Title of Change:	Conversion from polarity notch to polarity band on SMC packaged products.
Effective date:	9 March 2017 <i>or earlier upon customer approval</i>
Contact information:	Contact your local ON Semiconductor Sales Office or < SitiNurhaza.MohdRamli@onsemi.com > or < SengMun.Yoon@onsemi.com >
Type of notification:	This Product Bulletin (PB) is sent to customers. PB is issued 90 days prior to implementation of the change. ON Semiconductor will consider this change accepted, unless an inquiry is made in writing within 30 days of delivery of this notice. To do so, contact < PCN.Support@onsemi.com >.
Change category:	☐ Wafer Fab Change ☒ Assembly Change ☐ Test Change ☐ Other _____

Description and Purpose:

Figure 1

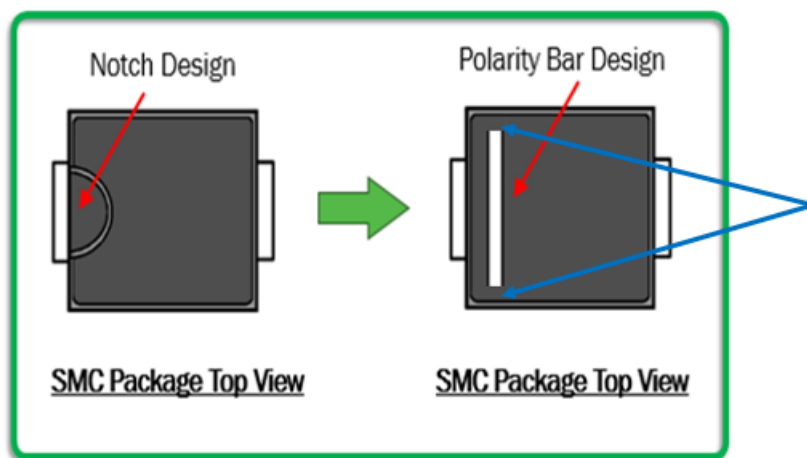
This Product Bulletin is announcing that ON Semiconductor Malaysia is converting the diode polarity identification for SMC packaged devices from a notch molded into the epoxy body of the device to a laser marked polarity band. The change will align ON Semiconductor Malaysia with the current industry standard for SMC polarity identification. The details of this change are displayed pictorially in Figure 1 below. An example device showing both the legacy notch that will be eliminated and the polarity band that will be replacing it is shown in Figure 2.

Band does not extend to edge of epoxy body
